Annotated Set with changes from DRB15-017 noted in red

DEL MAR CIVIC CENTER

MOD 16-002 CITY COUNCIL

Modifications (MOD16-002) to a previously-approved Design Review Permit (DRB15-017) for minor changes to the City Hall/Town Hall/Plaza Project. The requested modifications include the following: various design revisions to the building façade, windows and doors, and west parking garage elevation, Town Hall roof material, landscaping, and plaza layout and features; addition of antennas and exhaust shaft; revisions to floor plans and parking garage layout (one-story garage proposed in lieu of two-story design); reduction from 160 to 140 parking stalls; addition of a new stairwell and pedestrian garage access near 10th Street; removal of a patio, gate and fence; modification of a vehicle entry ramp on the south elevation; and addition of a vehicle access between the garage and surface parking lot on the internal west elevation.

SHEET A-100.B

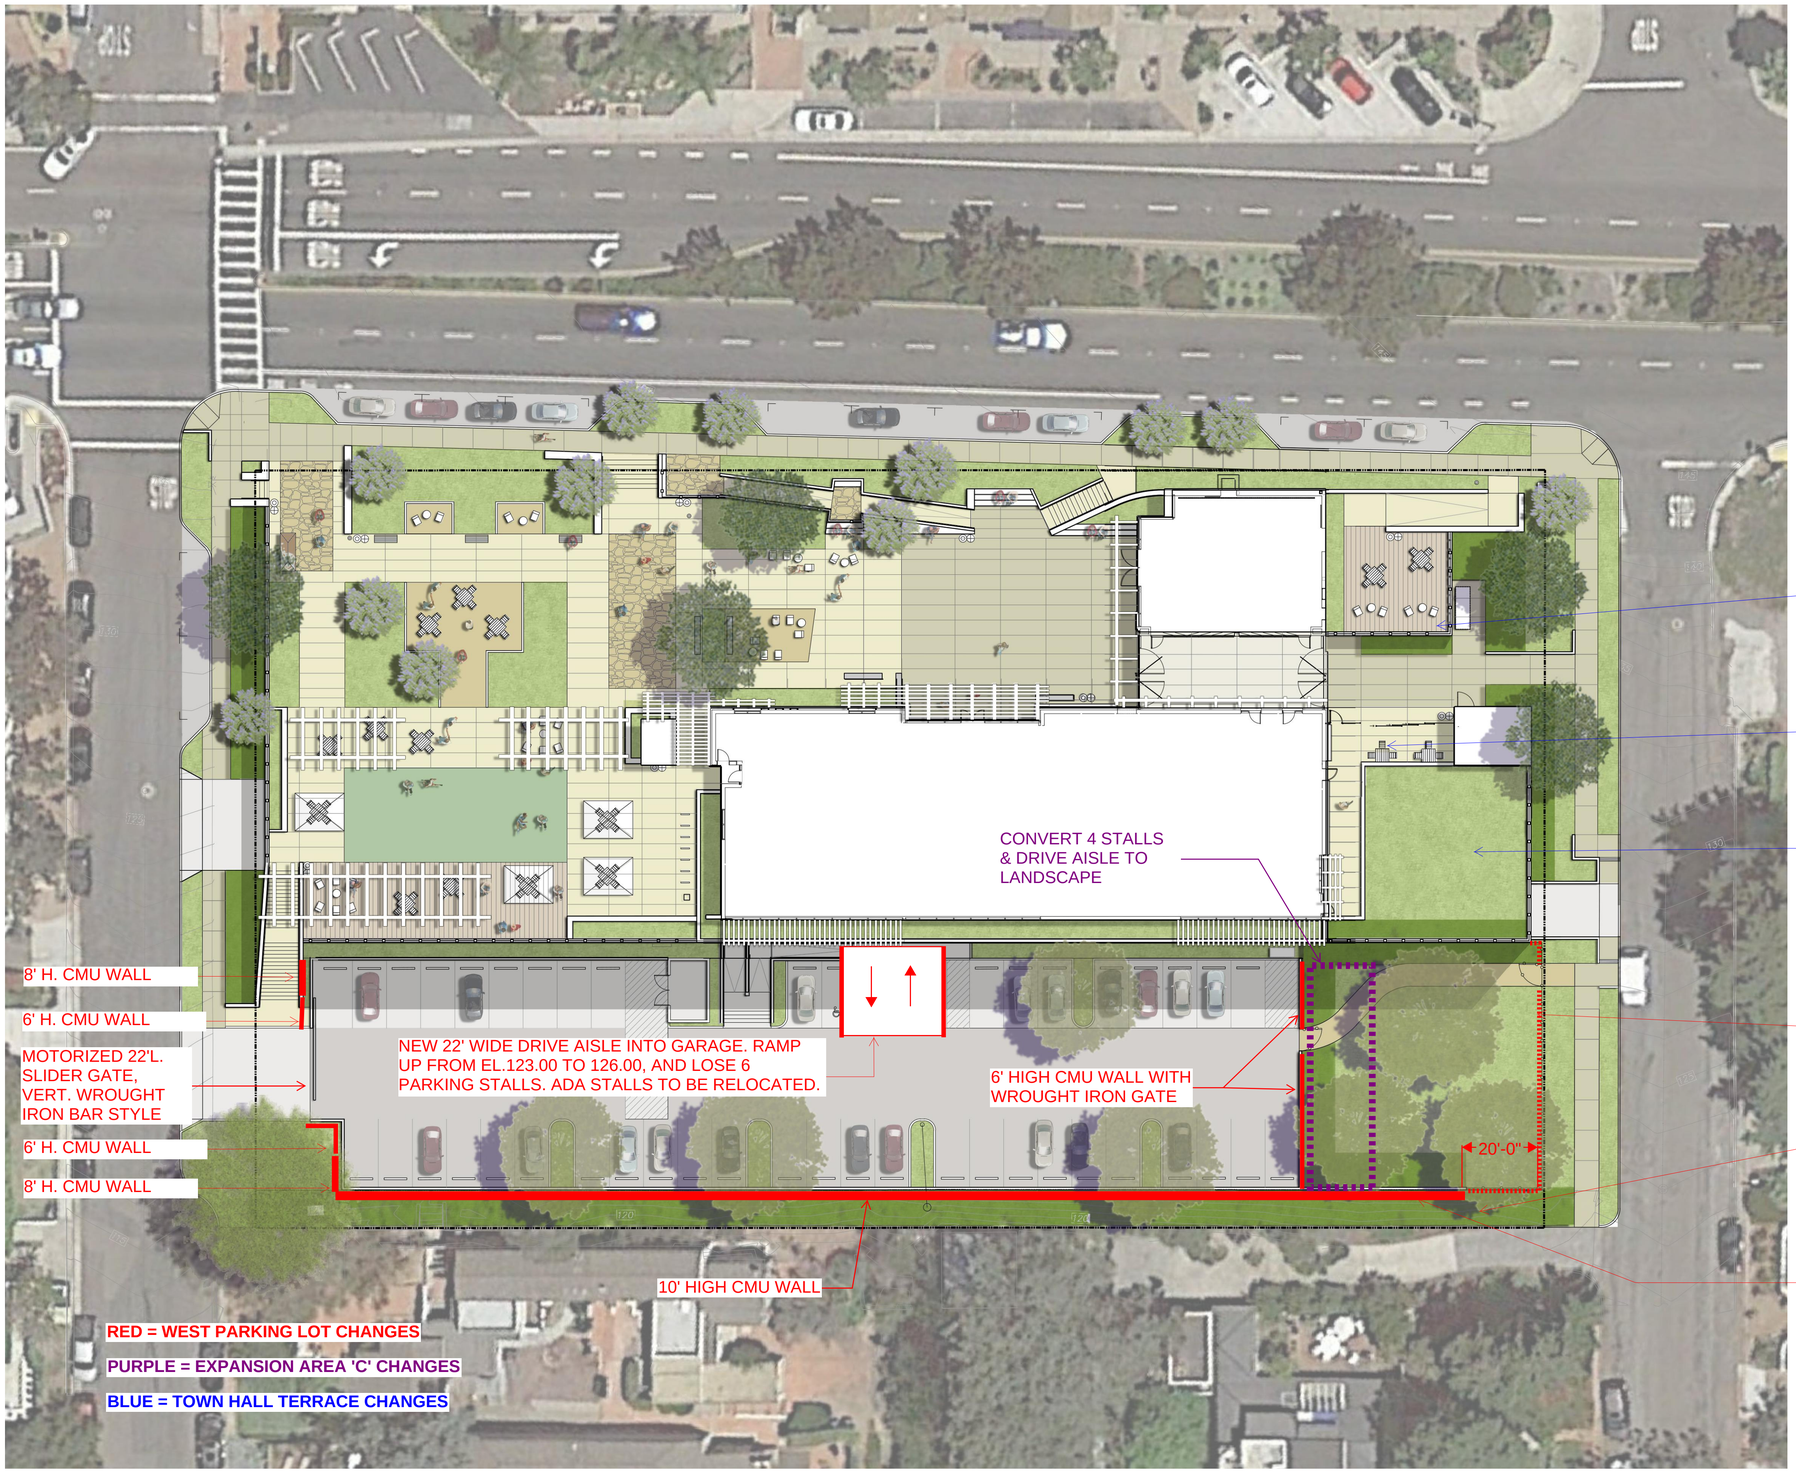
Recommended conditions for approval by Design Review Board Resolution December 16, 2015

REDUCE TOWN HALL OVERLOOK BY APPROX. 5 FEET FROM WESTERN EDGE, CONVERT EDGE TO PLANTER OR OTHER BARRIER

Del Mar Civic Center
Trellis Redesign Options
Miller Hull - 5/26/16

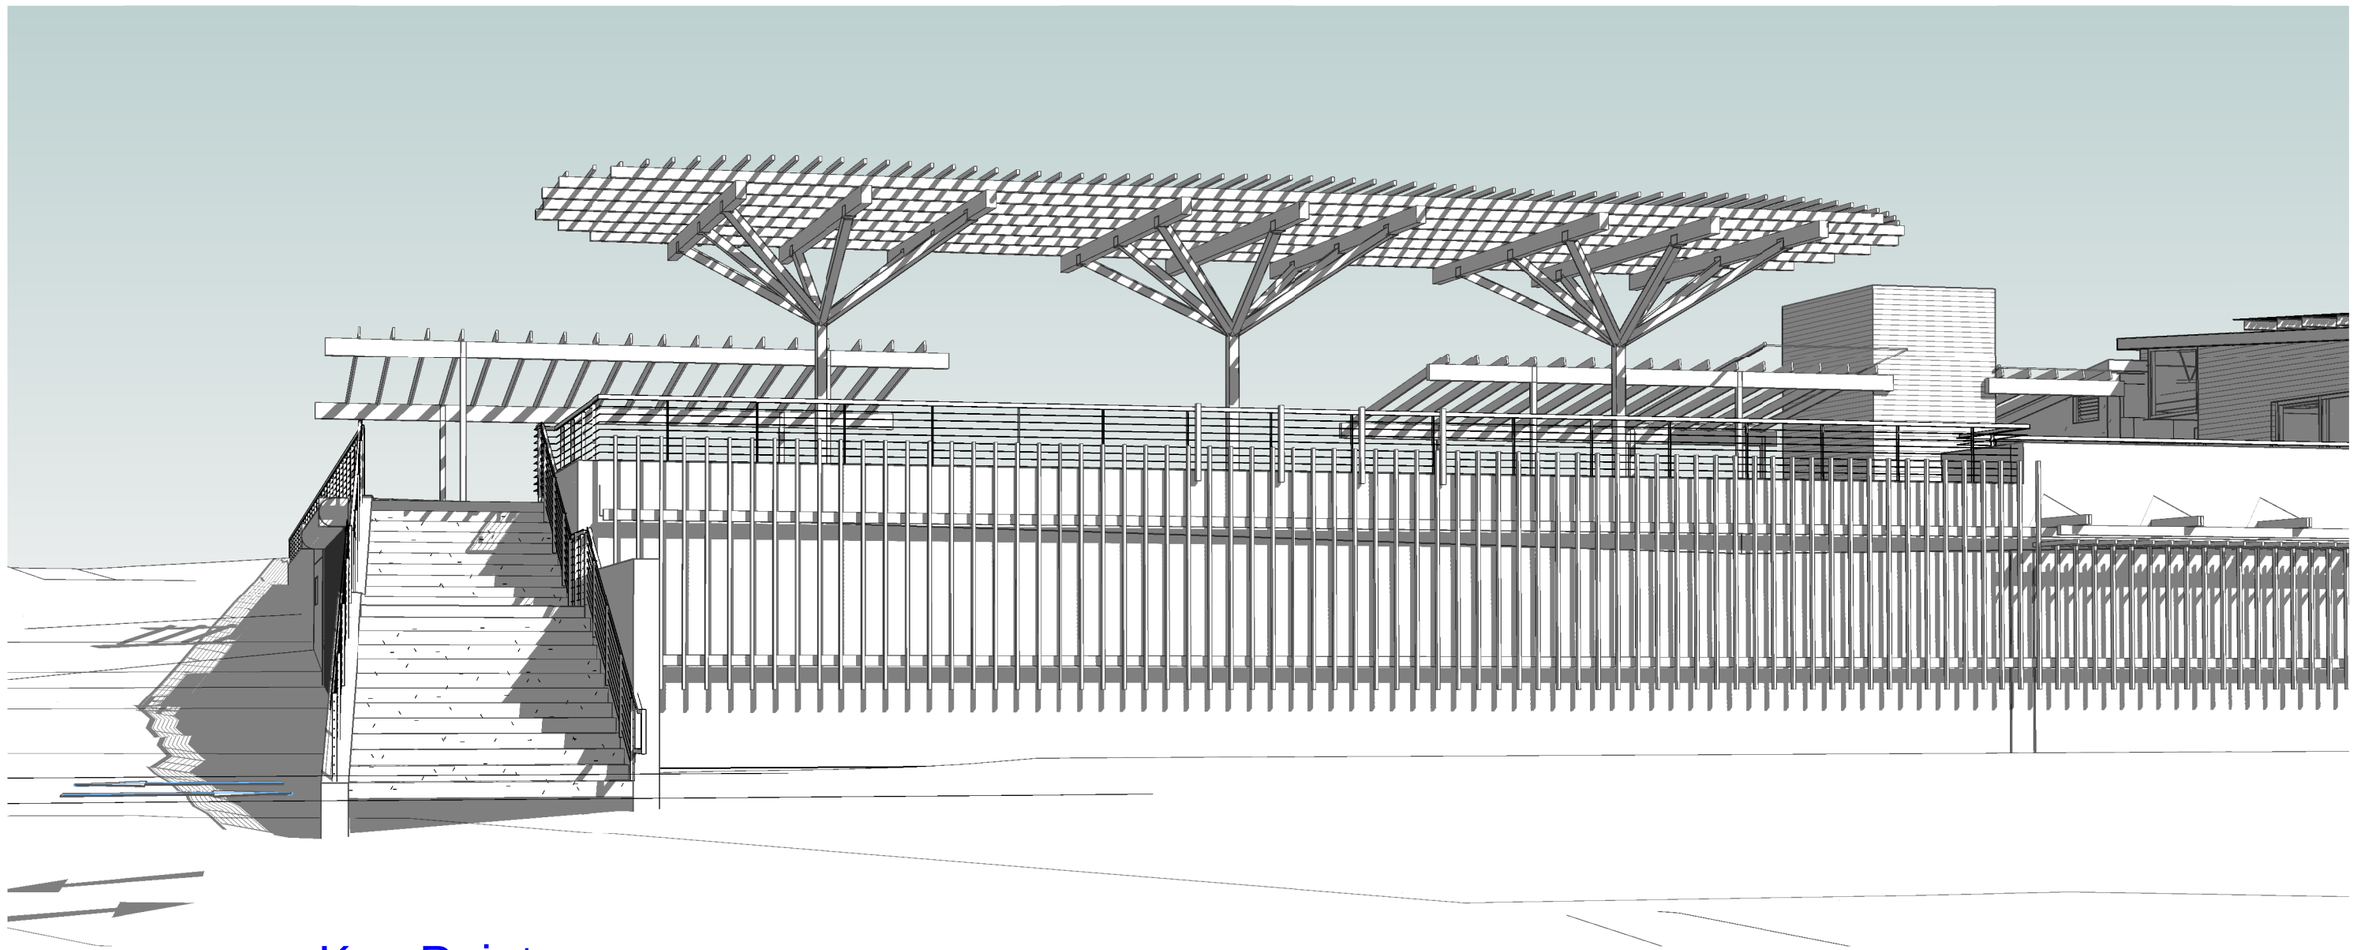
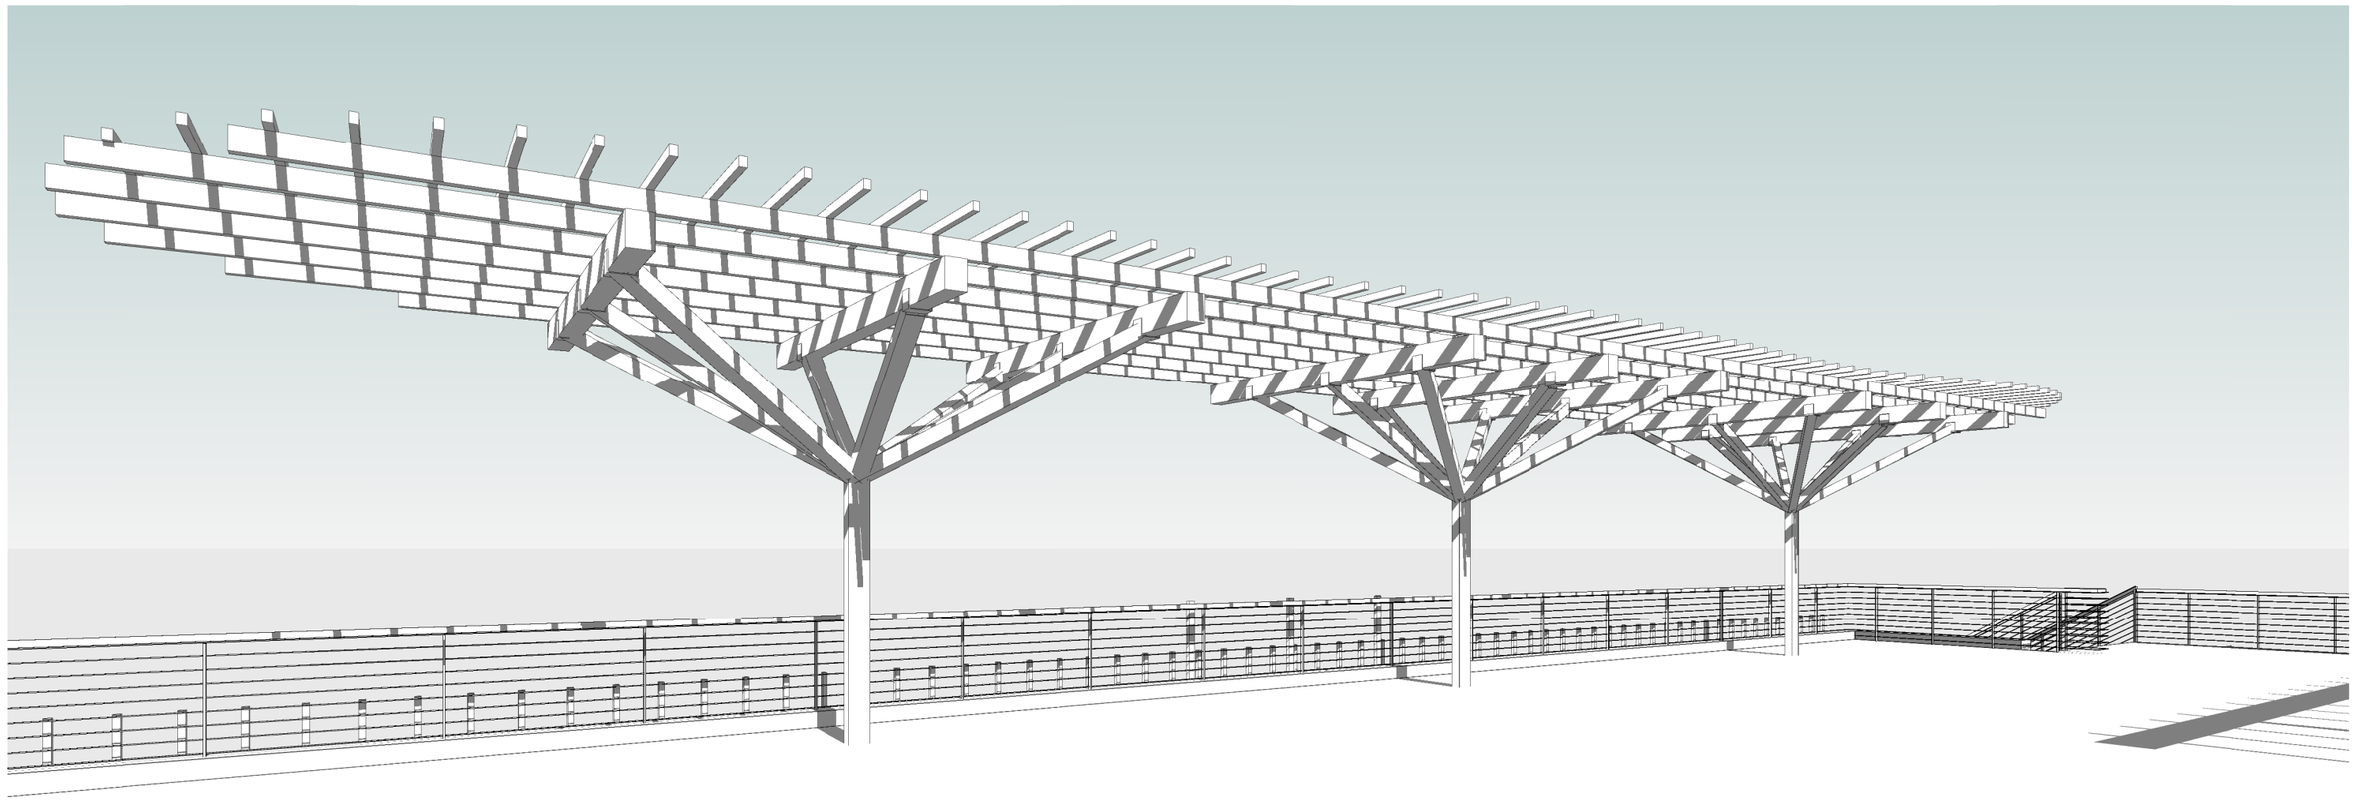
Key Points:
- Closely matches rendering in original DRB Materials Board packet (12/7/15)
- Posts reduced to 3 in single row
- Posts do not extend down face of garage
- Canopy does not extend over stair

OPTION 2

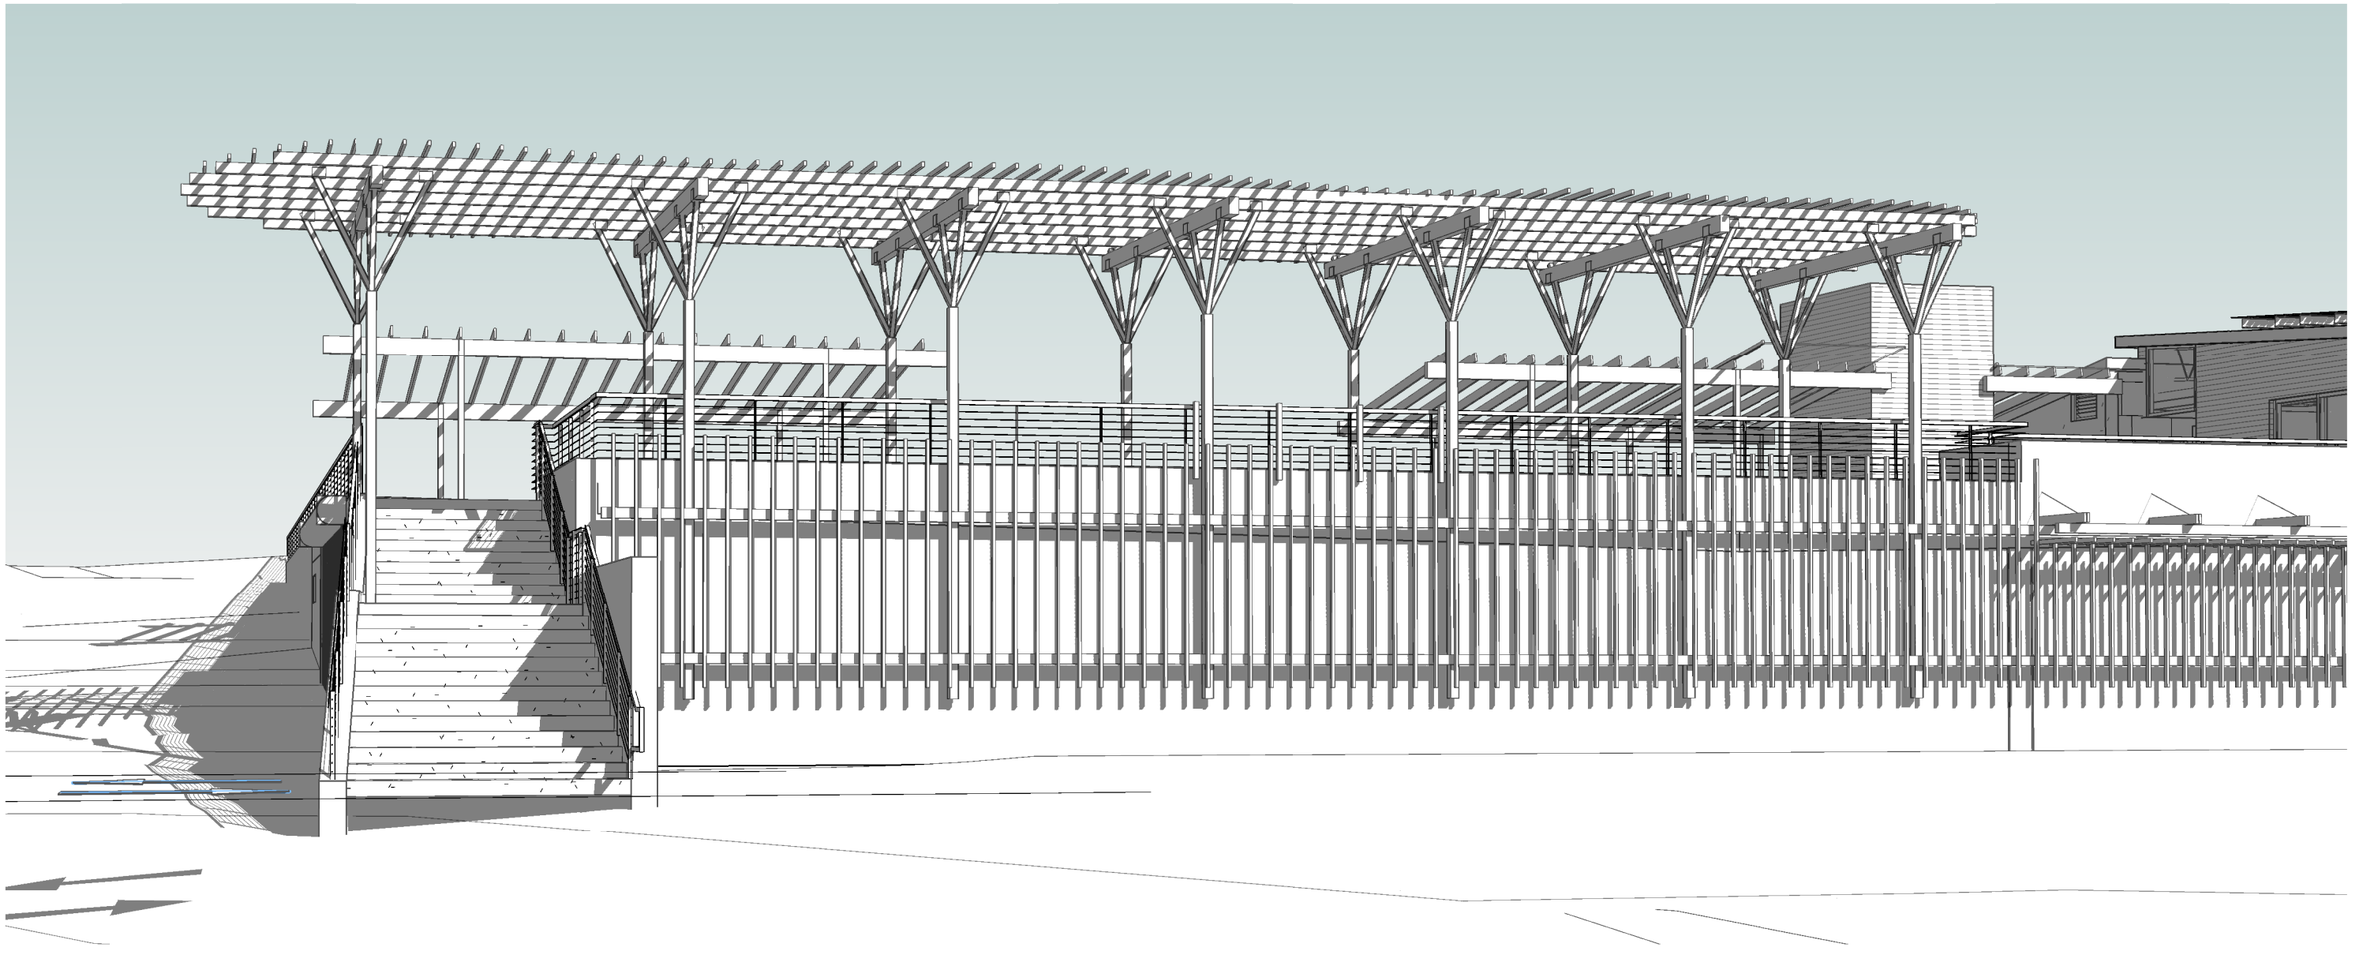
Key Points:
- Posts aligned in double row to create outdoor room (14 posts total)
- West posts extend down face of garage
- Canopy extends over stair
